From: [Denise Charlebois](#)
To: [Camille Leung](#); [Planning Commission](#); [Timothy Fox](#); [Steve Monowitz](#); mhaesloop@chsdg.com; [Gregory Smith](#); [Heather Forshey](#)
Subject: 634 Palomar Dr. PLN2020-00251 June 21 Planning hearing D. Enea
Date: Thursday, June 15, 2023 3:02:47 PM
Attachments: [D.Enea Planning Commission 6-21-23.pdf](#)
[223016 Wet Season 2023 Effects Letter 20230615Balanced Hydrologis.pdf](#)
[Kilik 6-2023.pdf](#)
[Enviromental Health failed septic 6-2023.pdf](#)
[2022 Arborist report Richard Smith-stating stability of hill in jeopardy.pdf](#)
[Grading violafion 634 Palomar.pdf](#)
[21 Estrada Sewer hookup20080610 letter 051022430.pdf](#)
[Drainage report 738 Loma Ct 4-13-23 GCD Inc .pdf](#)

RE: 634 Palomar Dr. PLN2020-00251

Re: Summary of 2023 wet-season observations. County file number PLN 2020-00251

Re: Comment letter on the proposed residential development at APN 051-022-380, 634 Palomar Drive, Redwood City, CA

Figure 6. Basemap noting indications of slope instability and evidence of water near the proposed project at APN 051-022-380 636 Palomar Drive, Redwood City, San Mateo County, CA.

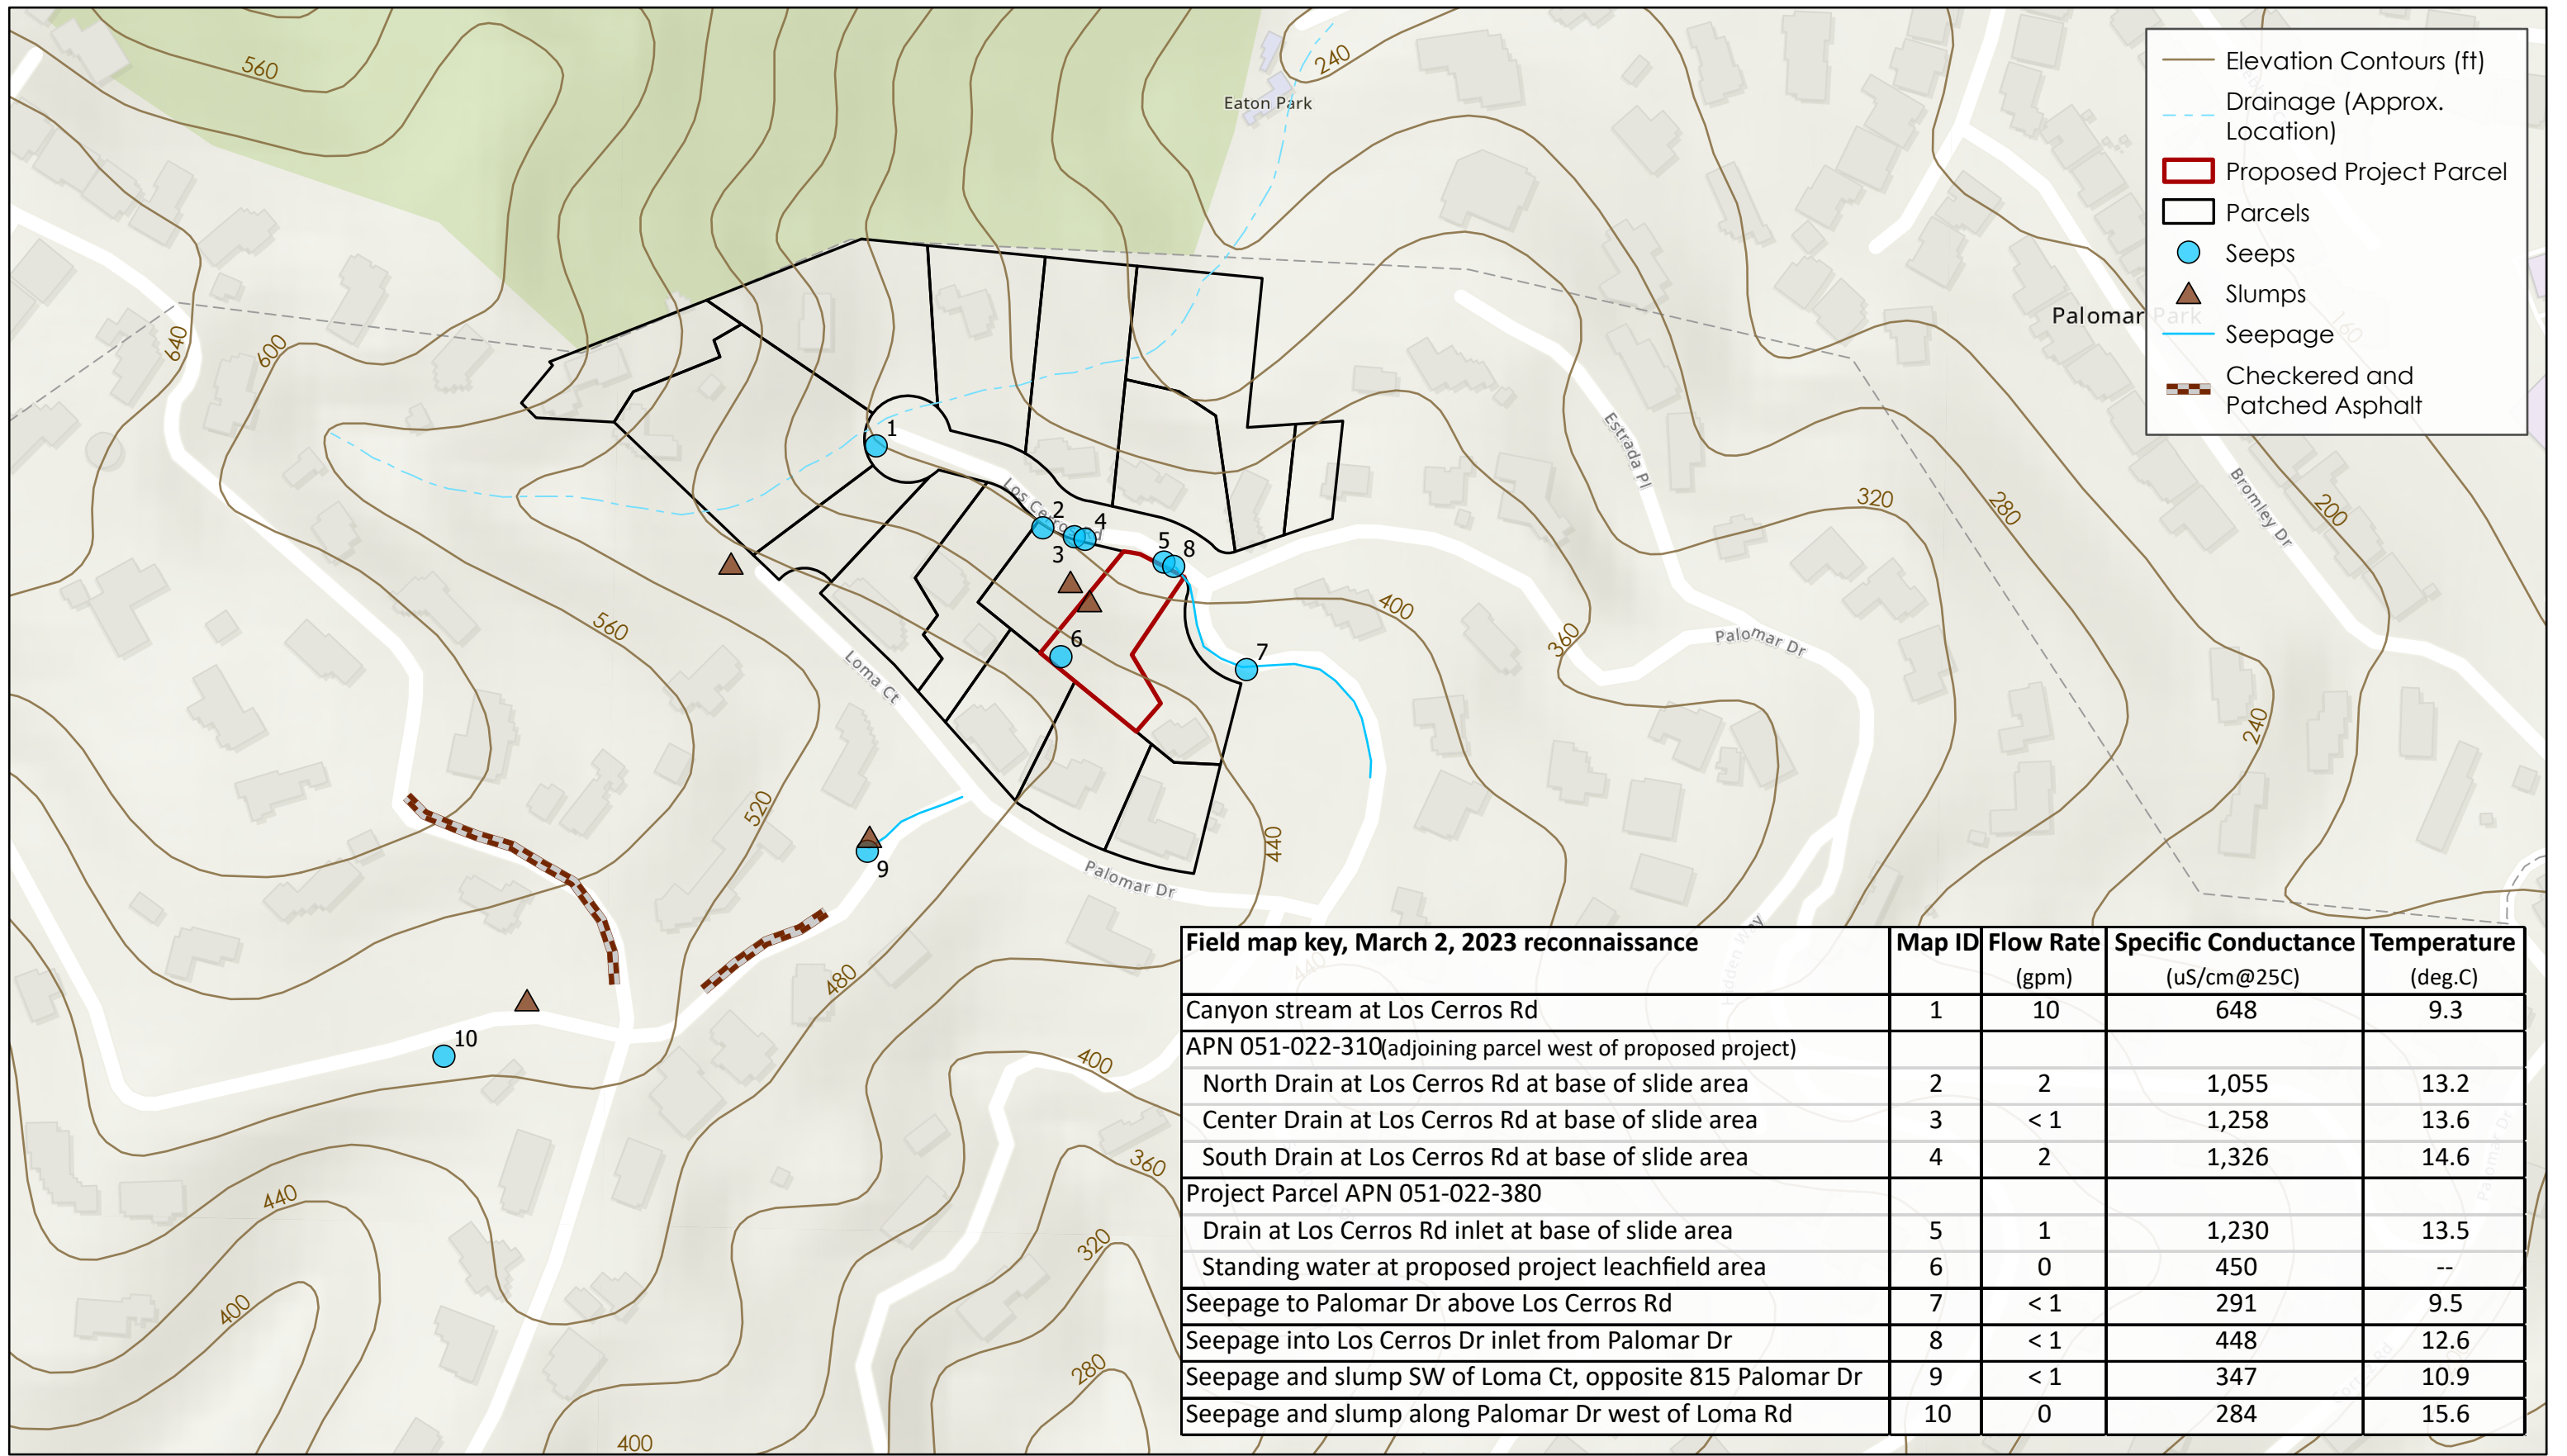
- We documented several new soil slumps, slipouts, and seepages in the area during 2023, including on the applicant's parcel and on the adjoining parcel 20 feet from the applicant's property line. Roots of mature oak and bay trees prevented expansion of these slides. And an emergency 4-inch subdrain was installed along this property line to collect seepage (Kilik Engineering letter of March 6, 2023).

- Information which we believe is not previously noted in the files is the indications of active earth movement at the upslope property line of the Enea parcel (APN 051-022-310). As seen from the Enea parcel, the 10-foot high whitewashed cinderblock retaining wall is bulging outward with up to several feet of displacement. The wall bears fresh, unweathered open cracks of up to ½ to 1 inch wide in what seems to be evidence of at least some recent downslope movement. One of the largest of these cracks is about 30 to 40 feet southwest of end of the proposed expansion leachfield, and within the 100-foot setback from the proposed septic system. The deformed cinderblock wall is readily visible from either the applicant's lot or Ms Enea's.

**Plate 2 of Atlas, 2020,
Geotechnical Report Update
Proposed Residential Development
634 Palomar Drive, Redwood City, California**

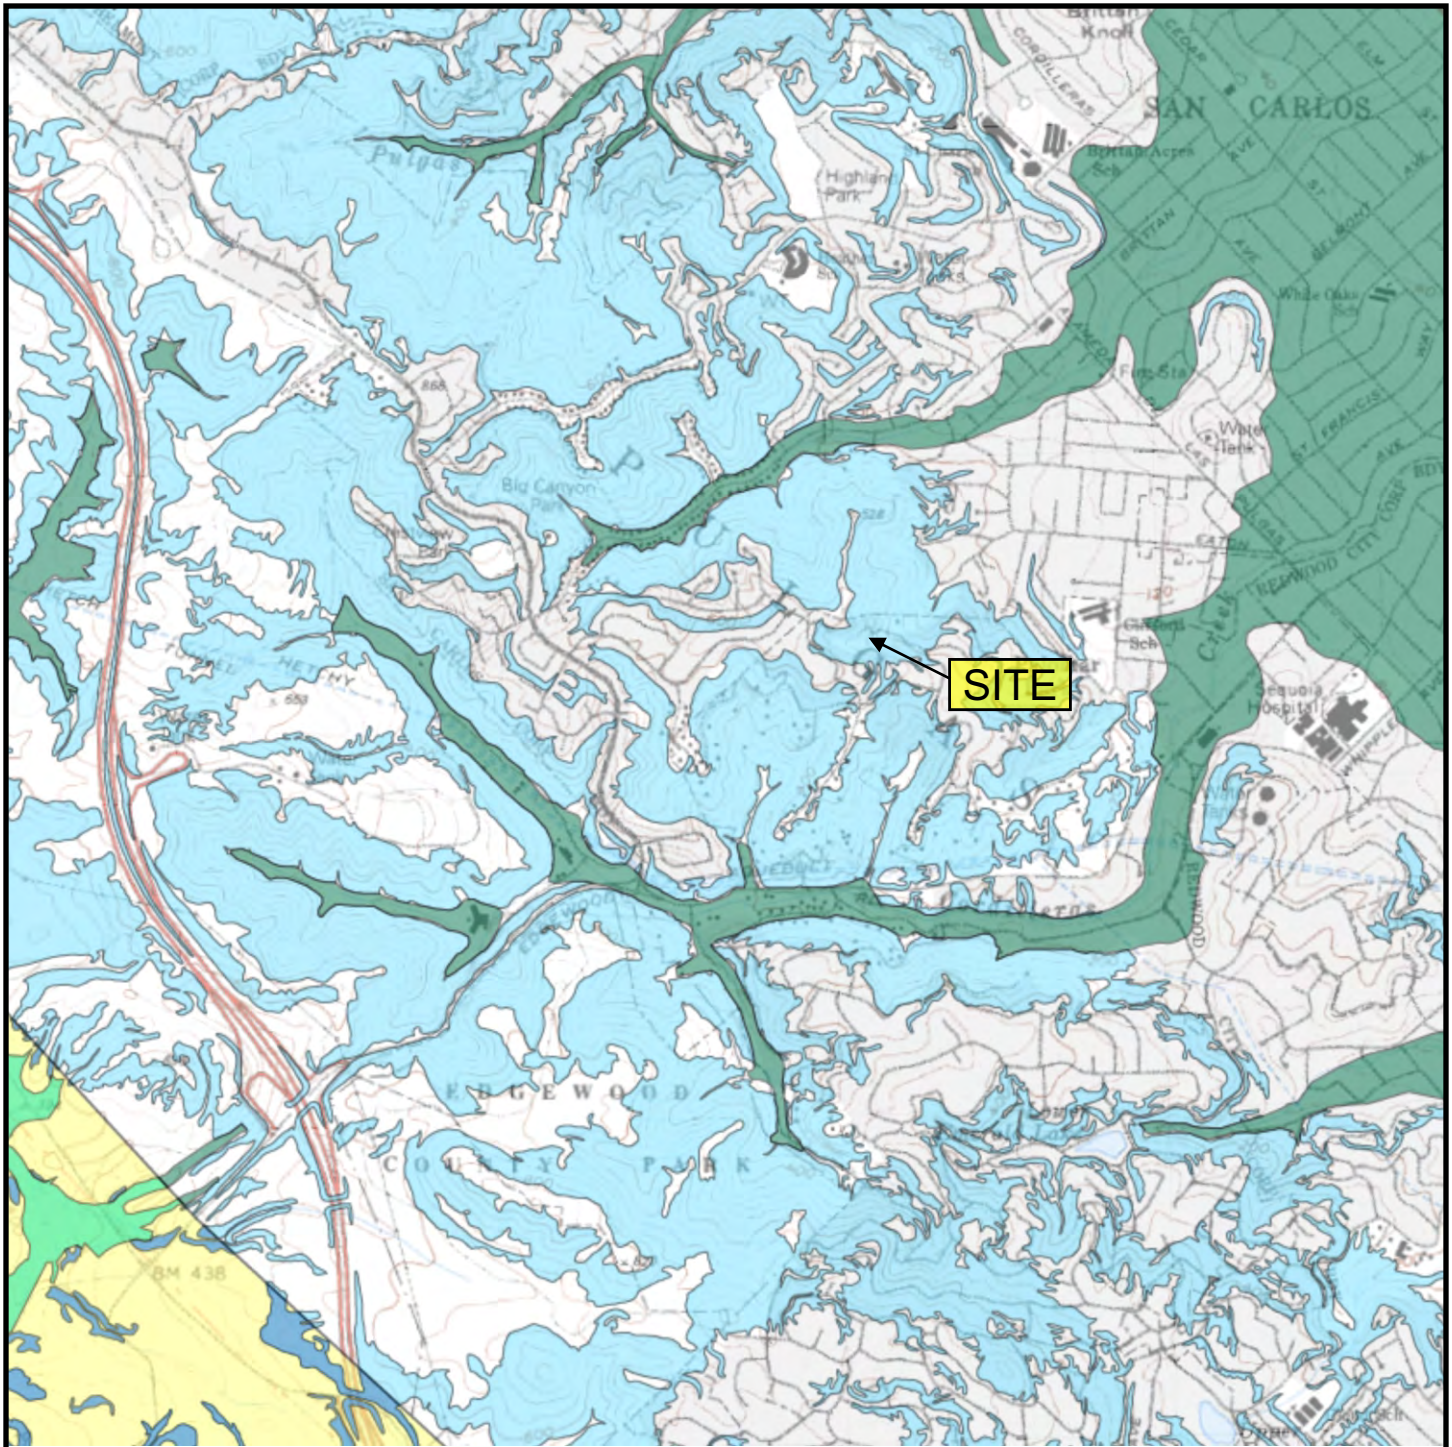
We have thus far not discussed seismic instability. Again, the effect of this project will be adding water to the chaotic blocks and the aquifer in between them. When the shaking starts, the instabilities will likely begin propagating where there is excess water, which may be next to the proposed project or several hundred feet away. The evidence, if we will listen it, is one of multiple landslides in the same locations, and sometimes at different depths, in response to growing amounts of water entering the slope and being retained in it.
